ALERT SERVICE BULLETIN
REVISION NOTICE
Bell Helicopter**TEXTRON**
A Subsidiary of Textron Inc.

SUBJECT: **REVISION "A" TO ALERT SERVICE BULLETIN 407-05-70:
CLEVIS ASSEMBLY – HYDRAULIC SERVO ASSEMBLY, PART
NUMBER 41011300 AND 41011400**

NO. 407-05-70

SUBJECT: CLEVIS ASSEMBLY – HYDRAULIC SERVO ASSEMBLIES, PART NUMBER 41011300 and 41011400

Clevis Assembly
 Figure 1

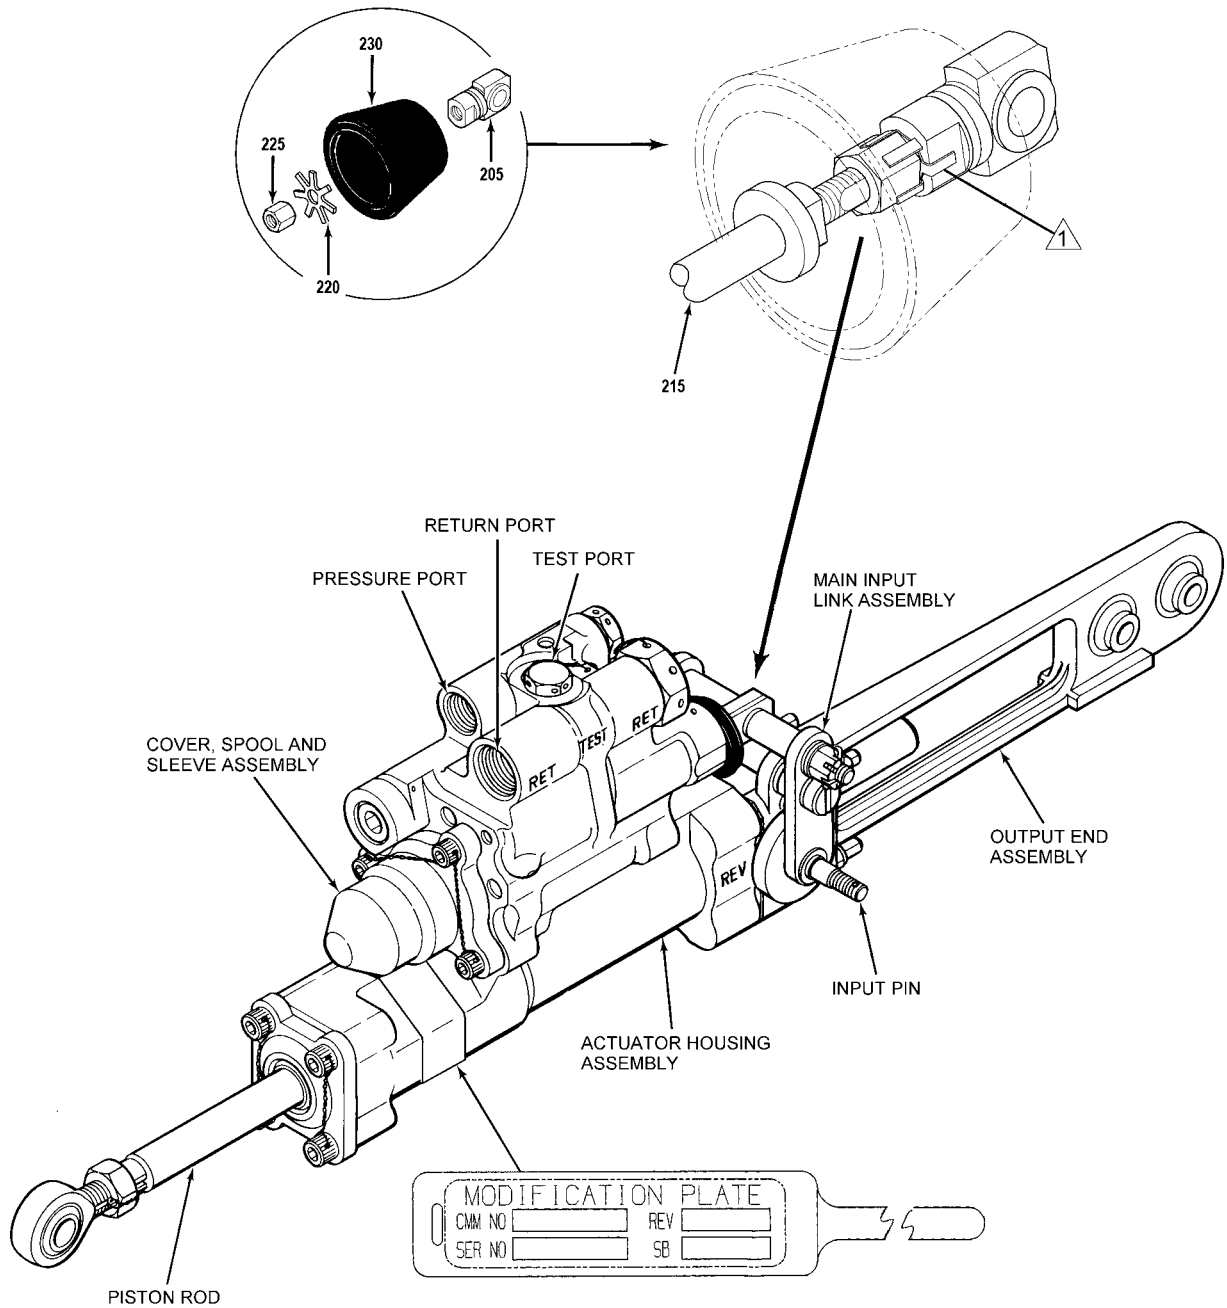
- The HR Textron Customer Service telephone number phone number, is added in Section 1, Step F.
- The compliance in Section 2, Step A, is changed.
- The inspection criteria are clarified in Section 2.
- HR Textron-Authorized Service Centers telephone and fax number are added in Table 1.
- A better graphic view of the proper installation is shown in Figure 1.

HR has discovered the possibility that the shaft (215) (refer to Figure 1) could be loose. The looseness is as a result of lock washer tabs (220), improperly bent over the flat surface of the nut (225) or the flat surface of the clevis assembly (205).

3. If the shaft is not turning independently from the nut or the clevis assembly proceed with step 2.B.4.
4. Check if at least one tab of the lock washer is bent flush against one of the nut flat surface and if at least one tab of the lock washer is bent flush against one of the two flat surfaces of the clevis assembly. Lock washer tab must also be in line with the flat surface of the nut and clevis assembly. If the lock washer tabs are not bent flush against the nut and clevis assembly or are not in line with the flats, proceed with the following steps.

5. If the lock washer tabs are not bent flush against the nut or clevis assembly flat surface, use needle-nosed pliers and make sure the lock washer tab is flush against nut or the flat surface of the clevis assembly.

- △ ACCEPTABLE CONDITION
 A MINIMUM OF ONE TAB SHALL BE IN LINE AND BENT FLUSH WITH THE NUT FLAT SURFACE AND A MINIMUM OF ONE TAB SHALL BE IN LINE AND BENT FLUSH WITH THE CLEVIS ASSEMBLY FLAT SURFACE

Clevis Assembly
 Figure 1

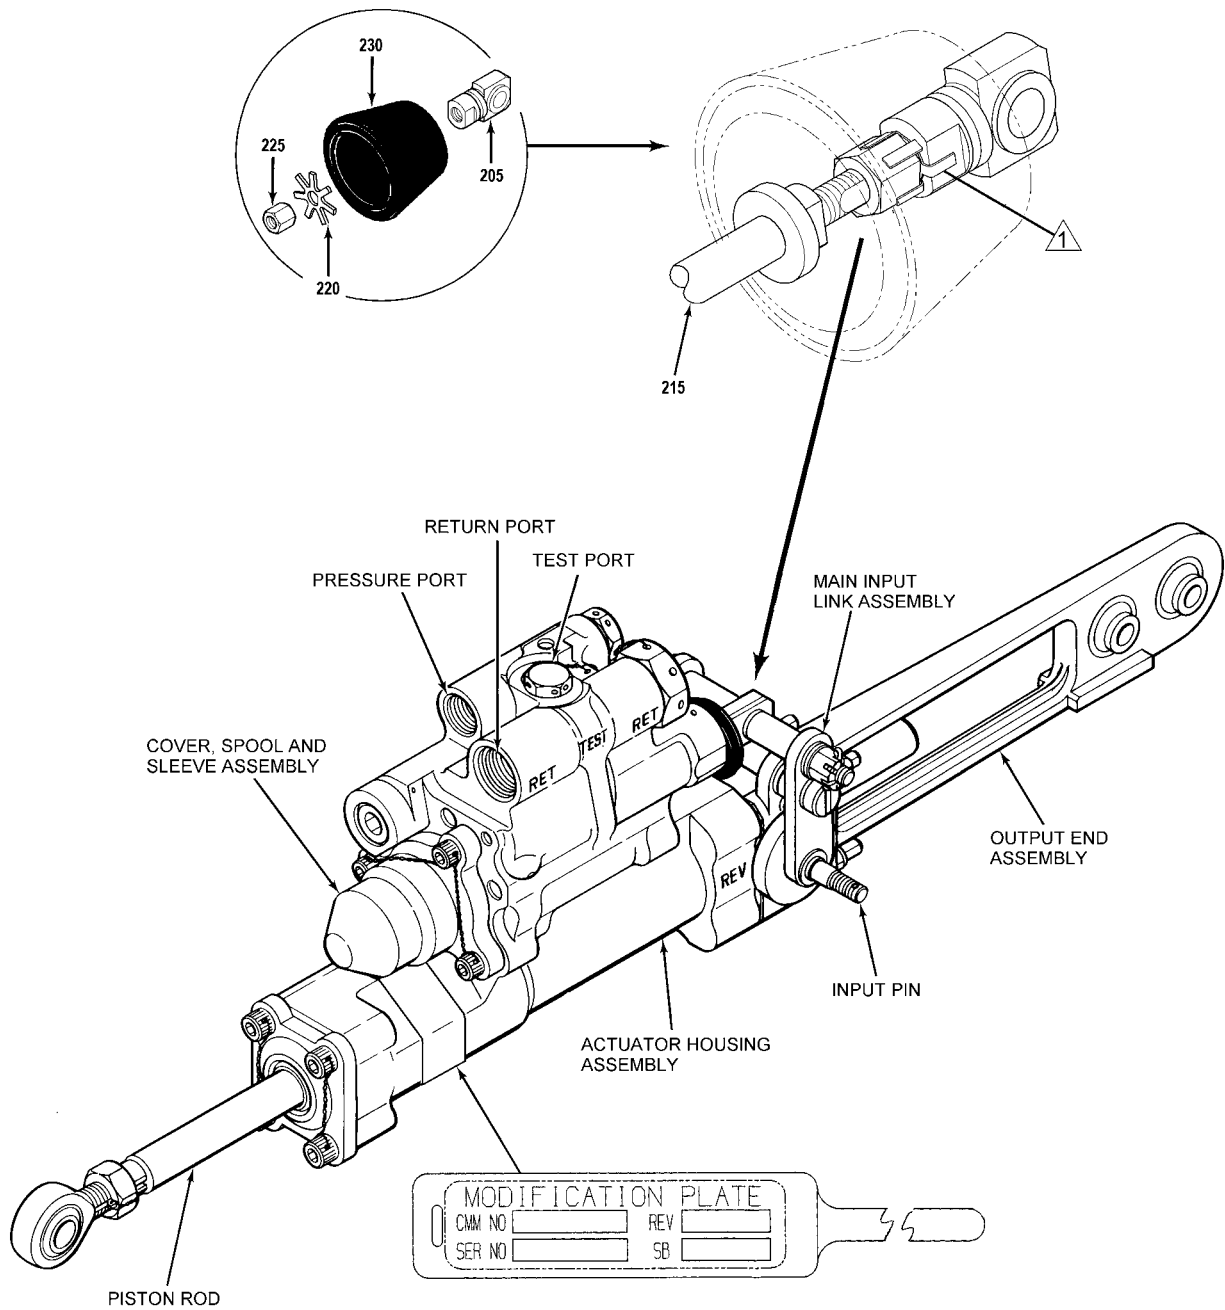
HR has discovered the possibility that the shaft (215) (refer to Figure 1) could be loose. The looseness is as a result of lock washer tabs (220), improperly bent over the flat surface of the nut (225) or the flat surface of the clevis assembly (205).

3. If the shaft is not turning independently from the nut or the clevis assembly proceed with step 2.B.4.
4. Check if at least one tab of the lock washer is bent flush against one of the nut flat surface and if at least one tab of the lock washer is bent flush against one of the two flat surfaces of the clevis assembly. Lock washer tab must also be in line with the flat surface of the nut and clevis assembly. If the lock washer tabs are not bent flush against the nut and clevis assembly or are not in line with the flats, proceed with the following steps.

5. If the lock washer tabs are not bent flush against the nut or clevis assembly flat surface, use needle-nosed pliers and make sure the lock washer tab is flush against nut or the flat surface of the clevis assembly.

- △ ACCEPTABLE CONDITION
 A MINIMUM OF ONE TAB SHALL BE IN LINE AND BENT FLUSH WITH THE NUT FLAT SURFACE AND A MINIMUM OF ONE TAB SHALL BE IN LINE AND BENT FLUSH WITH THE CLEVIS ASSEMBLY FLAT SURFACE
